Model: iR2200/2800/3300 Series

Ref. No. : FF-T01-L5-000045-02

Location: Controller Box

Subject: Doing away with the Fan Motor

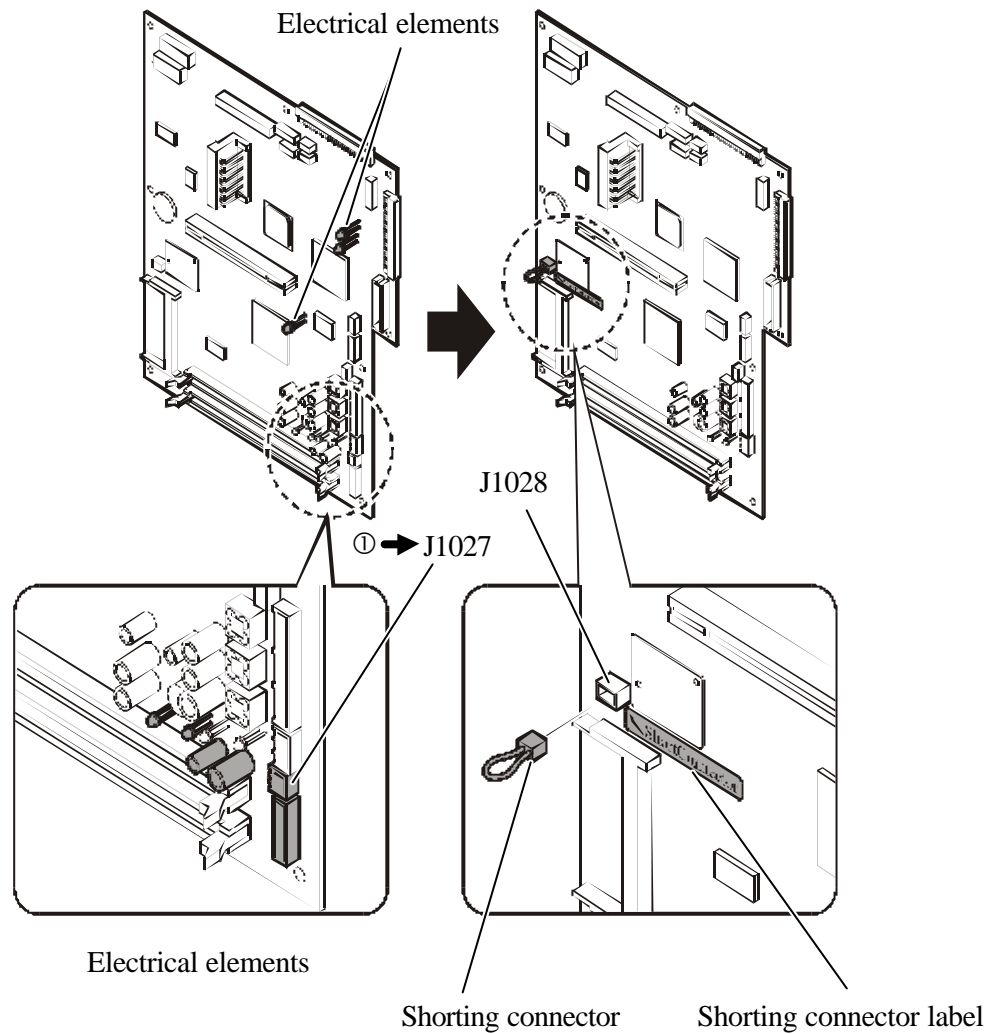
Detail: Because of doing away with the fan motor, the fan motor circuit on the main controller PCB is also disused, thus the electrical elements are removed from the list of service parts.

The blank connector (J1028) appears after the disuse of the fan motor, and attaches the shorting connector (newly set up as a service part) to the blank connector.

To confirm the presence of the shorting connector easily, affix the shorting connector label to near the shorting connector on the main controller PCB.

- When attaching the new main controller PCB to the old controller box, detach the unnecessary fan motor from the old controller box.
- In addition, because J1027 is deleted from the new main controller PCB, there is no location to connect the harness connector. However, a machine performs properly even if the harness connector is unconnected, so do not connect the connector to anywhere on the new main controller PCB.
- Contrariwise, when attaching the old main controller PCB to the new controller box (not the fan motor mounted), replace the shorting connector from the new main controller PCB to the old main controller PCB.
